Range <b>H&amp;C</b>	Model <b>OPERA TOUCH – CONCERTO TOUCH</b>	N° T.I. <b>12_2018</b>
Serial Number <b>82610688</b>	Subject <b>CHANGE OF CPU BOARD CONNECTION</b>

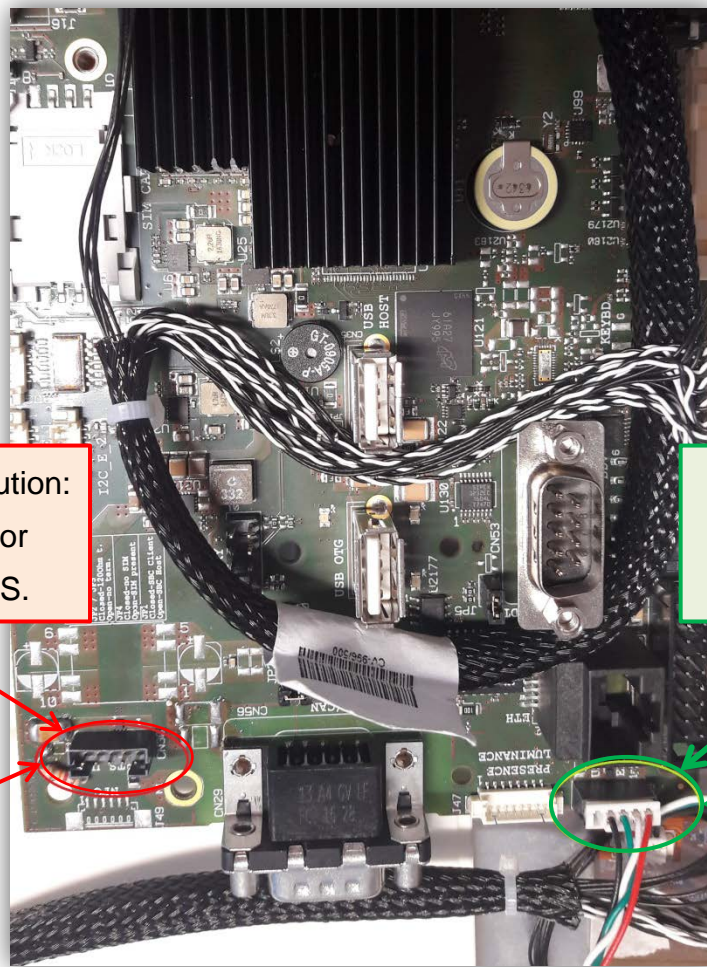
To make the **CPU board** less sensitive to external disturbances:

the **CPU** connection with **touch – screen** has been modified as shown in the picture below.

Pre-modification solution:  
**connector** used for connection with T.S.

N. connector  
**CN30**

New solution:  
**connector** used for connection with T.S.

N. connector  
**CN9**

➤ **Machines concerned by modification from S/N: 82610688**

The **CPU board** spare code is not changed: **261137**
